PCI-SIG ENGINEERING CHANGE NOTICE

TITLE:	OCuLink Cable Spec ECN
DATE:	March 23, 2018
AFFECTED DOCUMENT:	OCuLink 1.0
SPONSOR:	Alex Haser (Molex), Jay Neer (Molex)

The IL/ fitted IL requirements have been clarified. The language of this portion of the spec has been reworked to eliminate confusion and provide uniformity in the subsections included in the following document.

Figure 7-55: ~~Example~~ Maximum Mated Cable Assembly Insertion Loss

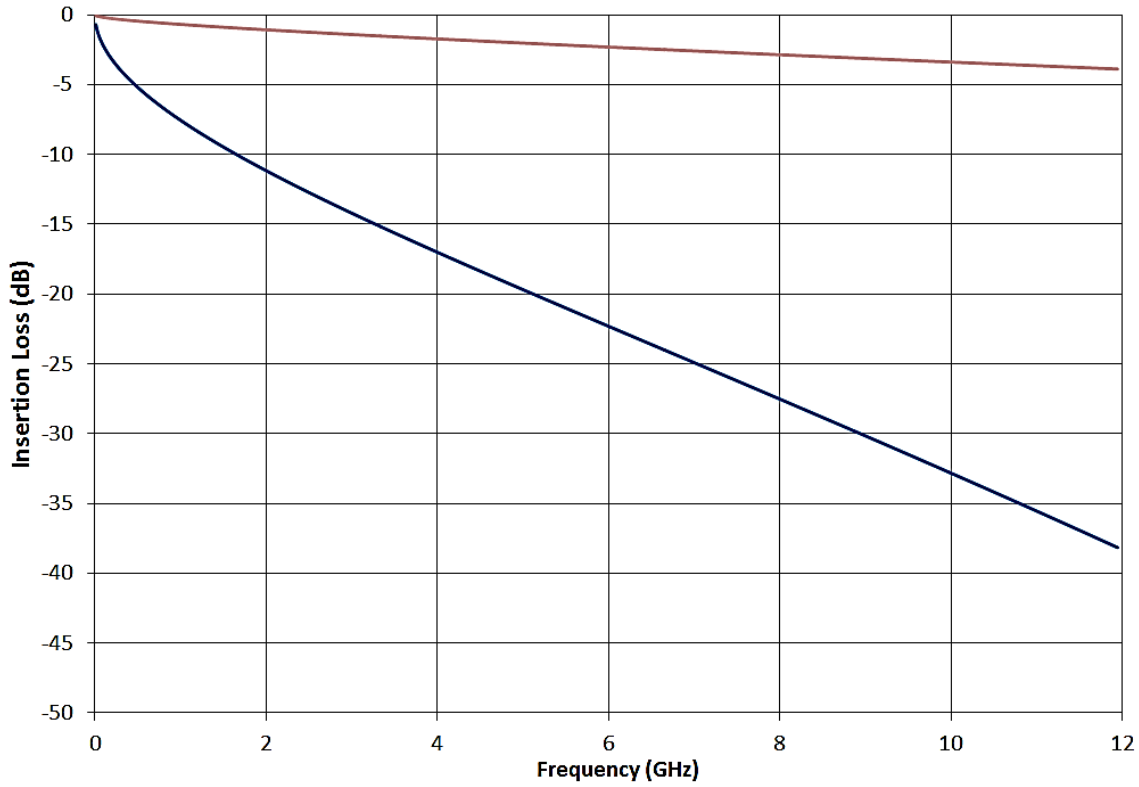
The differential insertion loss of each pair of a mated OCuLink cable assembly, in dB, must be less than the maximum limit defined in Equation 7-1, as illustrated in Figure 7-5.

Equation 7-1
$$IL_{Cable}(f) = 2 + 5.5\sqrt{f} + 0.5 f \quad \text{for } 0.05 \text{ GHz} \leq f \leq f_b \text{ GHz}$$

4 Examples of maximum and minimum fitted insertion loss are illustrated in Figure 7-5. The coefficients for the
5 maximum loss curve are: $a_1 = 6.9$, $a_2 = 0.6$, and $a_4 = 0.05$.

6 The coefficients for the minimum loss curve are: $a_1 = 0.5$, $a_2 = 0.18$, and $a_4 = 0$.

Figure 7 ~~Error! No text of specified style in document.~~ 16: Minimum Mated Cable Assembly Return Loss

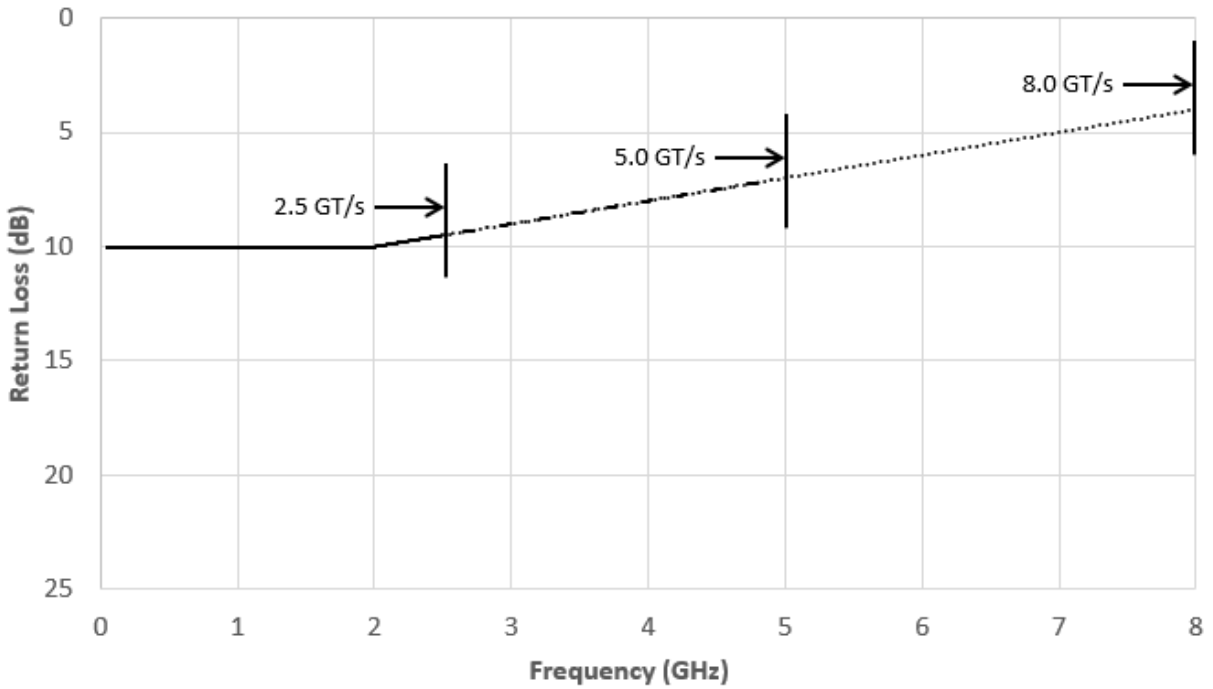
The differential return loss of each pair of the mated OCuLink cable assembly, in dB, must be greater than the minimum limit defined in~~meet the values determined using~~ Equation (7-24), as illustrated in Figure 7-6.

$$RL_{Cable}(f) = \begin{cases} 10 \text{ dB} & \text{for } 0.05 \text{ GHz} \leq f \leq 2 \text{ GHz} \\ (12 - f) \text{ dB} & \text{for } 2 \text{ GHz} < f \leq f_b \text{ GHz} \end{cases}$$

Figure ~~Error! No text of specified style in document.~~7-27: Minimum Mated
Cable Assembly Differential to Common-mode ~~Cable Assembly~~
Return Loss

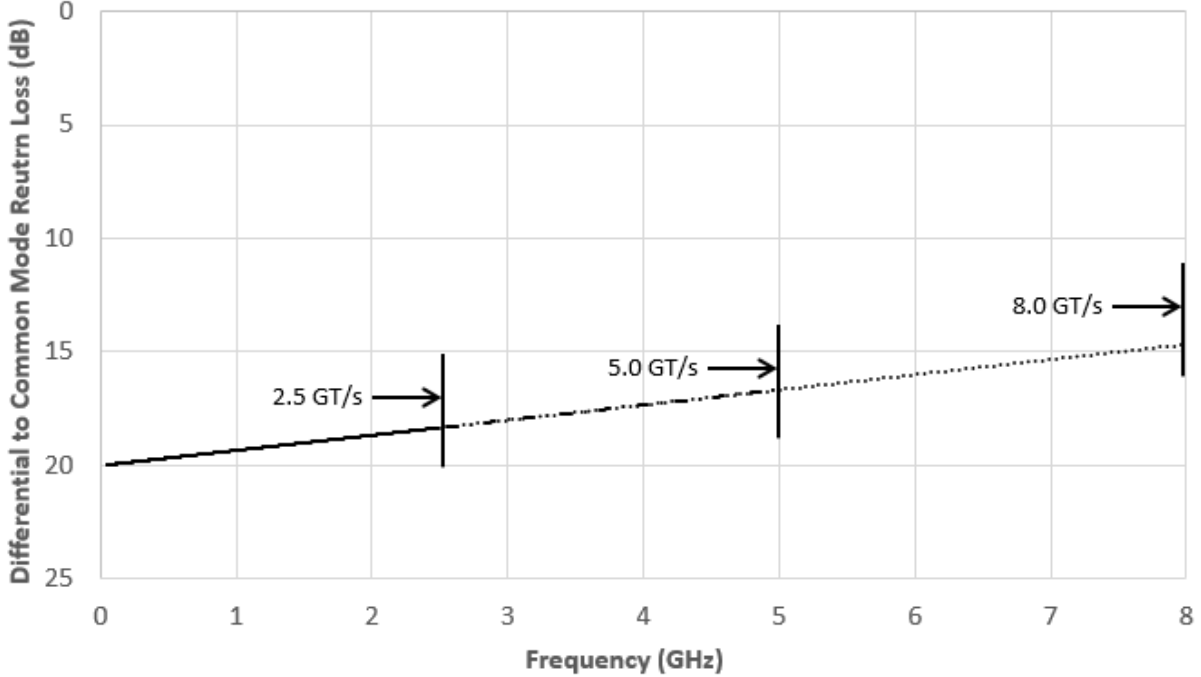
The differential to common-mode return loss of the mated OcuLink cable assembly, in dB, ~~of the cable assembly~~ must be greater than the minimum defined in ~~meet~~ Equation (7-35), ~~as~~ which is illustrated in ~~Figure 7-7~~.

Equation 7-3
$$DCMCCable(f) = 20 - \left(\frac{2}{3}\right) f$$
 for $0.05 \text{ GHz} \leq f \leq f_b \text{ GHz}$

Figure 7-8: Minimum Mated Cable Assembly MDNEXT Loss and MDFEXT Loss

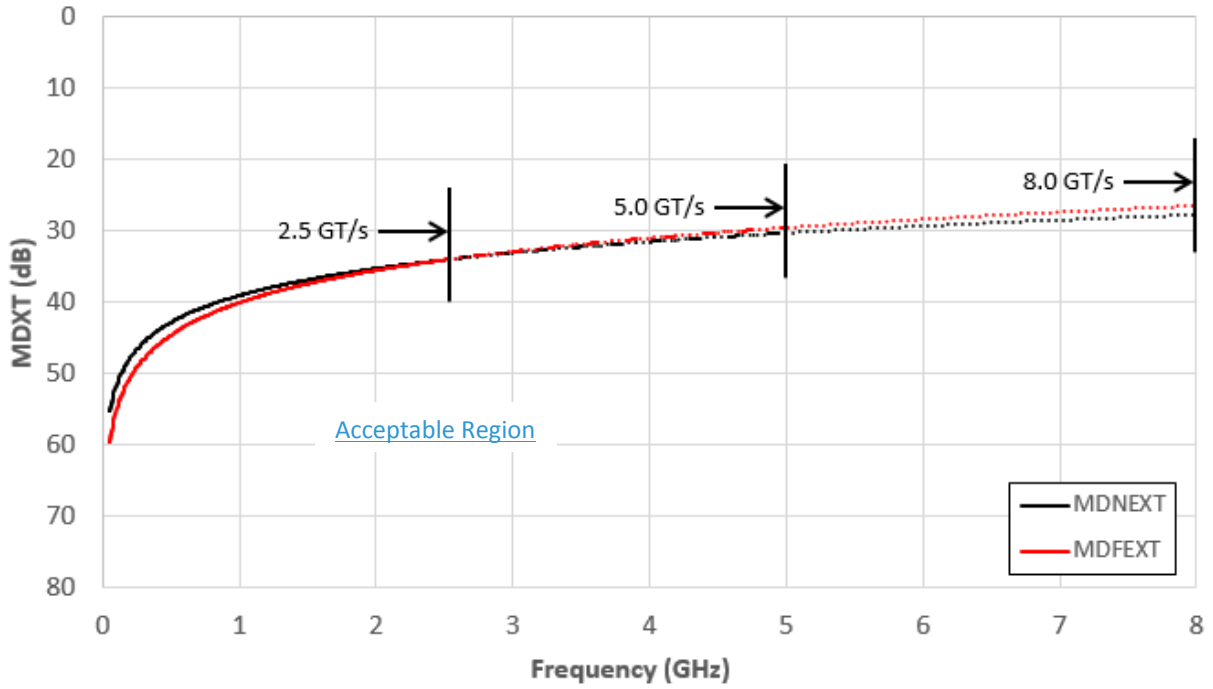
The MDNEXT loss and MDFEXT loss summed on each receive Lane of a mated OCuLink cable must be greater than the limits defined in Equations 7-8 and 7-9 respectively. These limits are illustrated in Figure 7-8.

Equation 7-8
$$\text{MDNEXT}_{\text{Cable}}(f) = 31.5 - 12.5 \log_{10} \left(\frac{f}{4} \right) \text{ dB} \quad \text{for } 0.05 \text{ GHz} \leq f \leq f_b \text{ GHz}$$

Equation 7-9
$$\text{MDFEXT}_{\text{Cable}}(f) = 31 - 15 \log_{10} \left(\frac{f}{4} \right) \text{ dB} \quad \text{for } 0.05 \text{ GHz} \leq f \leq f_b \text{ GHz}$$
